L-0700-019
January 9, 2020

**Re: Lonza Biologics G2E– Proposed Parking Expansion
Site Plan Review Application**

PROPOSED PARKING EXPANSION

LONZA BIOLOGICS

CODE	COMMON NAME	SIZE	REMARKS
TREES			
AC	ACERX FREEMANII 'ARMSTRONG'	ARMSTRONG MAPLE	2 1/2 - 3" CALIPER B & B
AR	ACER RUBRUM 'REDPOINTE'	REDPOINTE RED MAPLE	2 1/2 - 3" CALIPER B & B

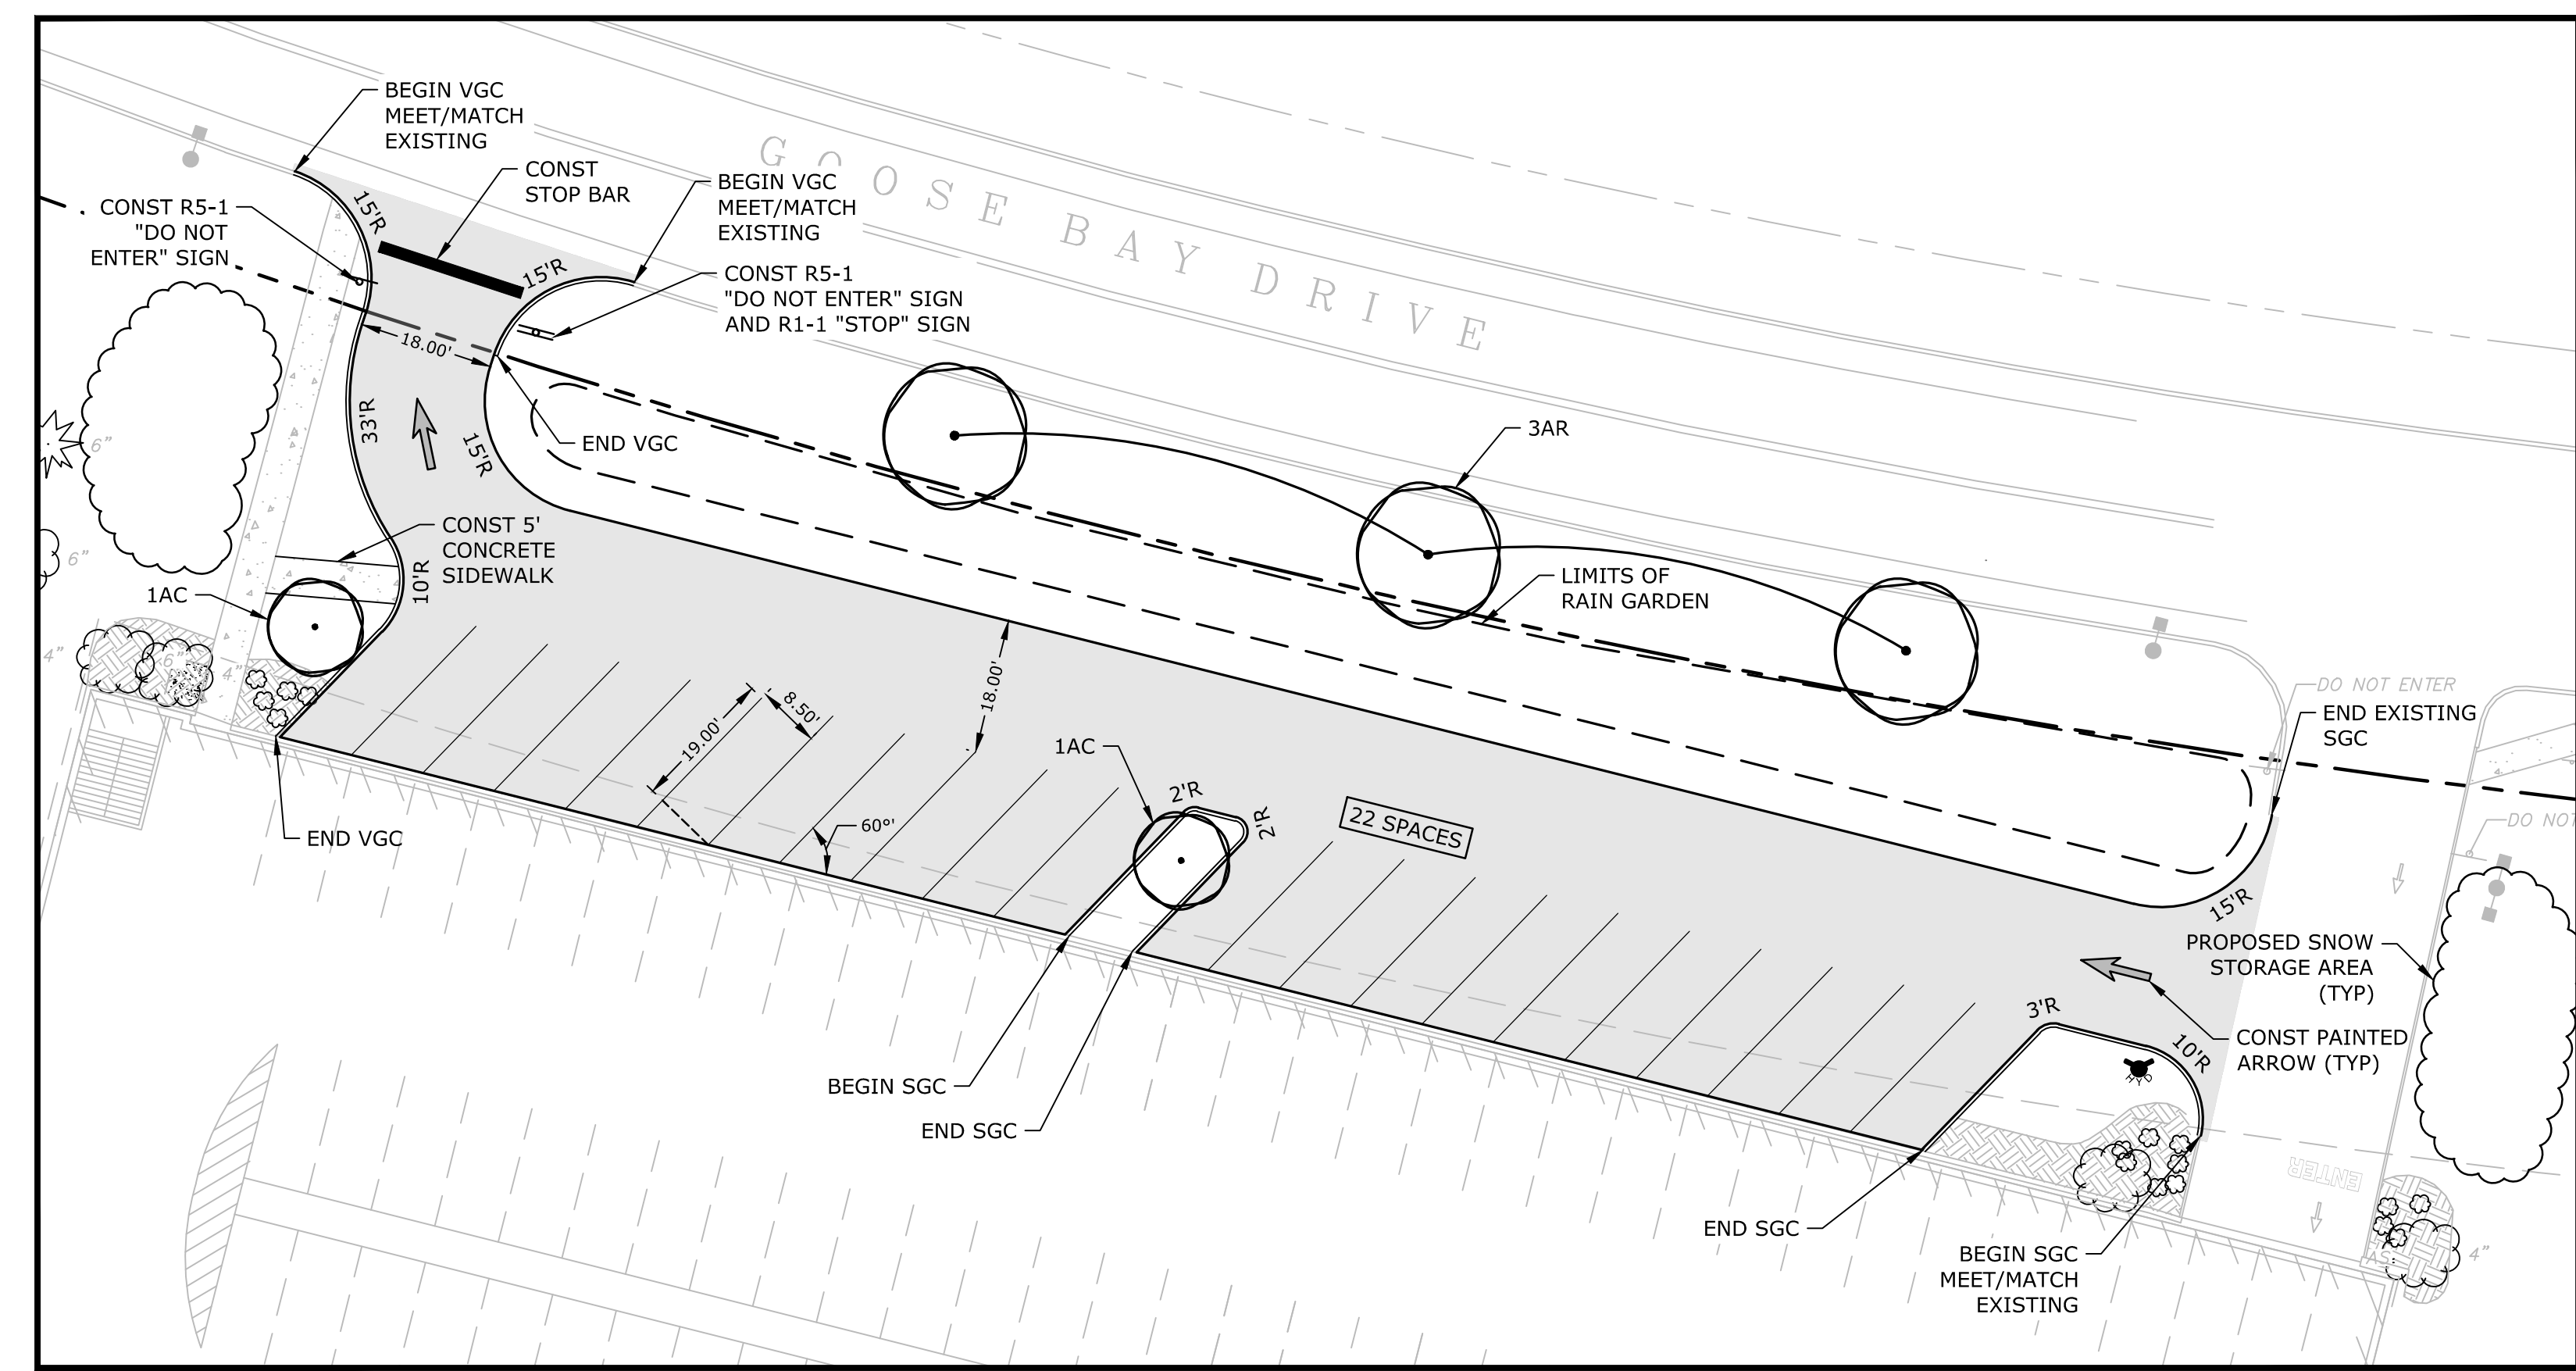
1. Plans shall be updated to include two more additional ADA spaces, closest to the building entrance, as required by standards.

2. Plans shall be updated to show replacement trees along the road where new parking is proposed, consistent with those that are planned for the opposite side of the road.

The number of required ADA parking spaces have been calculated by considering the garage and surface parking lots as two separate parking facilities. This makes the total required number of ADA spaces 15. There are 11 existing ADA spaces on site and an additional 4 ADA spaces have been added to the plans.

Trees have been added to the plans along Goose Bay Drive to replace the trees being removed as part of this project. Tree species have been chosen to match the trees planned for the opposite side of the road.
